Observations and comments on Trestle Replacement presentation by Yves Zsutty, July 9, 2013
Notes by L. Ames, 7/10/13. [With my personal commentary denoted by square brackets.]

Option 1

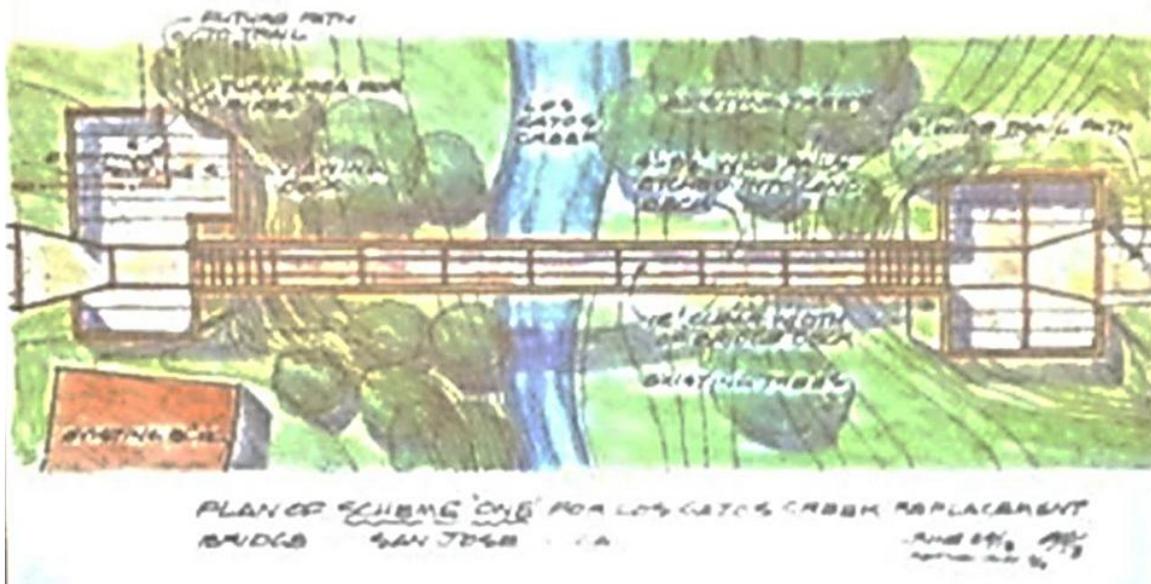
- * option 1 had square gateway areas walled with wire-mesh fencing and “railroad-like” scoring patterns in the concrete;

[Personal opinion: I felt like a kid being told, “Johnny, you >will< go to Aunt Millie’s today. You >will< wear your blue pants; you >will< wear your striped shirt. Now, you are an empowered individual who is free to make your own decisions and I value your input: do you want to put your left shoe on first or the right one?”]
